Opel Corsa-D - Front brake system

Front brake system

Squeaking noises when braking

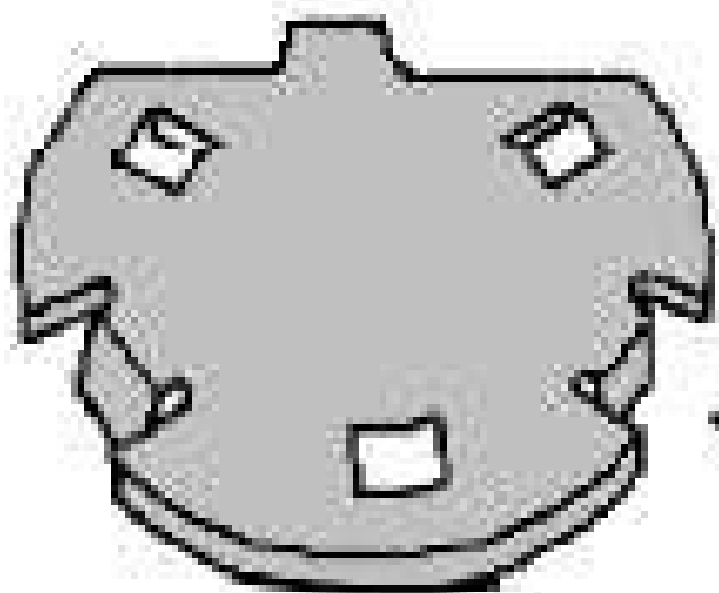
If the symptom specified above cannot be allocated to any detectable defect on the wheel brake, one possible cause of this is an insufficient decoupling between the brake pad and the brake caliper. For improving comfort, the vehicle manufacturers have installed so-called "Piston Caps" in the piston (A) of the brake calipers.

In case of a complaint, this must be checked and renewed where appropriate. On vehicles affected without "Piston Caps", these can be retrofitted.

These additional "Piston Caps" (B) have been introduced to the production from the following chassis numbers.

Spare part number "Piston Cap": Opel 93169307
